Appendix C

Review of "Air Water Transport in Large Diameter Piping Systems: Analysis and Evaluation of Large Diameter Testing Performed at Purdue University," WCAP-17271

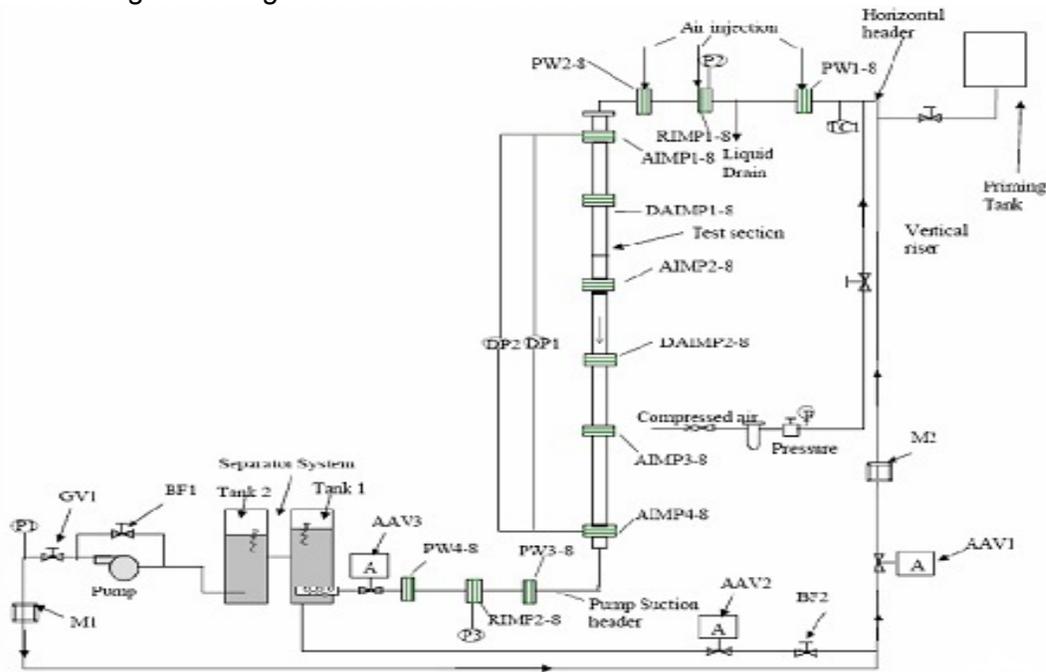
The pipes of interest are the upper horizontal header that is connected to a vertical downward-oriented test section that is connected to a lower horizontal pump suction header. Lengths are about 31, 27, and 17 feet, respectively. The RIMP, AIMP, and DIMP designations are for void instrumentation. A typical test may be described as consisting of the following steps⁶:

Test pressure was lower than generally occurs in plant ECCSs and an initial upper horizontal header pressure decrease was not typical of plant systems. The former causes voids to be a stronger function of elevation than in an ECCS. The latter introduces a transient that is not present in an ECCS, as discussed in the next paragraph. We do not judge these to detract from the data usefulness because if an analysis methodology predicts the challenging test conditions it should also be applicable to similar configurations in plant applications.

Standard Temperature Test conditions were set by closings Valves AAV1 and AAV3 with AAV2 open, BF2 set to simulate the resistance of the test section, and GV1 adjusted to obtain the desired flow rate as indicated on M1. Then the desired amount of air was introduced into the upper horizontal header at 14.7 psia. A test was initiated by opening AAV1 and AAV3 and closing AAV2. Since the separation system was at 14.7 psia, pressure in the upper horizontal header decreased to < 10 psia within a few seconds due to the difference in the head of water in the vertical test section and in the separation system. This caused the upper horizontal header air volume to expand in a manner atypical of flow initiation in a plant. Most tests were of this type.

Modified tests, termed Flow Initialization Tests, were run with AAV3 open so that the initial upper horizontal header pressure was reduced to minimize the initial pressure change. The WCAP compares the results from the Standard Temperature and Flow Initialization Tests and concludes that “the trends are very similar. Therefore, the effect of the flow initiation transient on the gas transport process is negligible.” If void fractions are compared on a graph with ordinates adjusted to overlay one set of data with the other, the WCAP conclusion regarding similar trends is substantiated. However, the peak void fractions differ by a factor of two and the time span

when voids are observed differs by about 25 percent. This does not support the conclusion that the effect of the flow initiation on the gas transport process is negligible.

Figure 1 Cavity Profiles for Fr=(a) 1.16; (b) 0.794; (c) 0.700; (d) 0.641; (e) 0.628; (f) 0.602

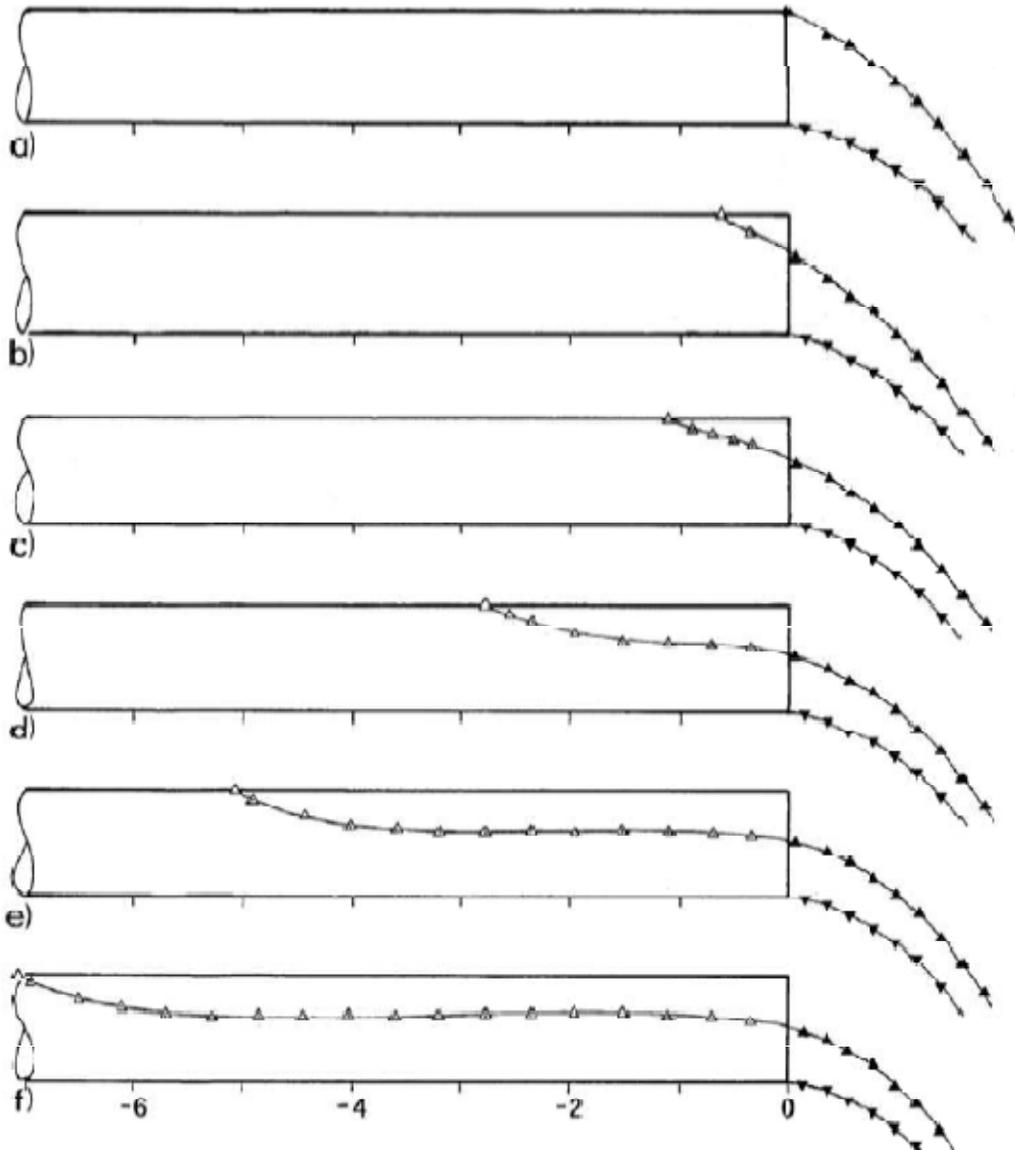
The WCAP states that an open-ended horizontal pipe will run full if $N_{FR} > 1.16$ and "all gas will be transported out of a horizontal piping section" if $N_{FR} \geq 1.0$ provided the downstream piping is sloped vertically upward. WCAP Figure 1, reproduced on the next page, illustrates the behavior. The Figure 1 criteria are acceptable.
